**Electromagnetic Effects Harmonization
Working Group (EEHWG)—Lightning
Task Group: Report on Aircraft
Lightning Strike Data**

DOT/FAA/AR-TN02/66

LIGHTNING TASK GROUP COMMENTS ON 1996 DATA

FIGURE A-1. SUMMARY OF ALL DATA – REPRESENTATION BASED ON DATA SUBSETS MUTUALLY INCLUSIVE

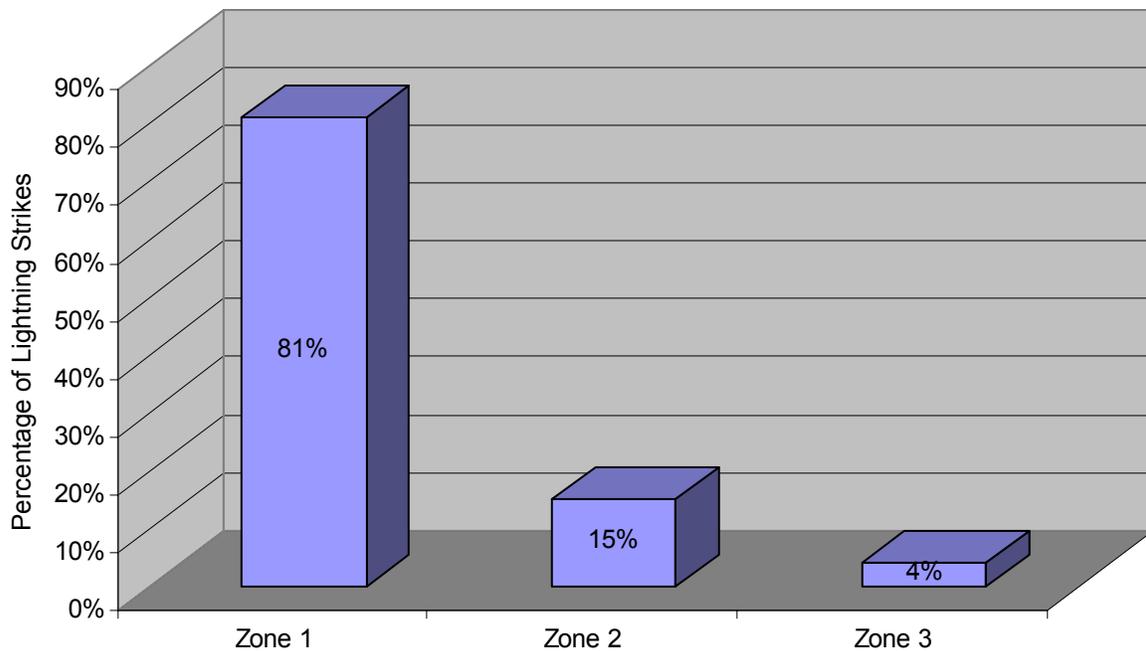
As written, the work conducted by Tapas Mukutmoni is confusing mainly due to the plots (as outlined in appendix A-1). He (Mukutmoni) says in conclusion, “drastic extension not justified” what does he mean; he should be more quantitative. Does he mean some extension is in order? Some people think a line extension is drastic, others would reserve the use of this word for an extension to include the whole aircraft.

At face value the plots imply percentage of strikes noted in zones defined by AC 20-53A. What constitutes a strike? An arc attachment? For a single incident, on this definition, there should be a single strike in Zone 1A and one in Zone 1B, i.e., two in Zone 1 in total

and any number in Zone 2, depending on the number of reattachments due to sweeping. AC 20-53A has nothing to say about the relative number of attachments in the Zone 1 and 2 regions, in fact, we would expect more arc attachments in Zone 2 as more strikes in Zone 1. However, there should be no attachments at all in Zone 3. In Mukutmoni's conclusion he does say damage for strikes in Zone 3 there should be no such strikes or does he mean one zone that can be allowed to occur in zone protected at the next level down is extremely small (see appendix A for these comments). On this basis all plots show violations against AC 20-53A given that they have strikes in Zone 3. In particular, the 23% of strikes to Dassault aircraft occurring in Zone 3 is very bad for AC 20-53A. I have never observed such a discrepancy, surely this is a mistake?

If the plots refer to initial return stroke attachments, all strikes should occur in Zone 1. I presume that cannot refer to this given that there are a lot of strikes in Zone 2. Do the plots refer to damage in the different zones? AC 20-53A says nothing about this except that if the protection has been done correctly there should be no flight safety endangering damage in any zone. Cosmetic or nonsafety critical damage can occur in all zones to any level deemed acceptable by the owner from point of view of maintenance/cost of ownership.

Therefore, the data presented either show too many attachments outside the AC 20-53A zones (Zone 3) or they are irrelevant. They say nothing about the restriction or not of severe strikes to Zone 1. Incidentally, if one reads AC 20-53A carefully it notes that occasionally first return strokes can occur aft of Zone 1A as defined and this possibility should be considered if such attachments would constitute a flight safety hazard. See 10.c.(1) last two sentences page 7. This concern I guess is why the FAA have gone for special conditions on composite aircraft and is the spirit of the new drafts.
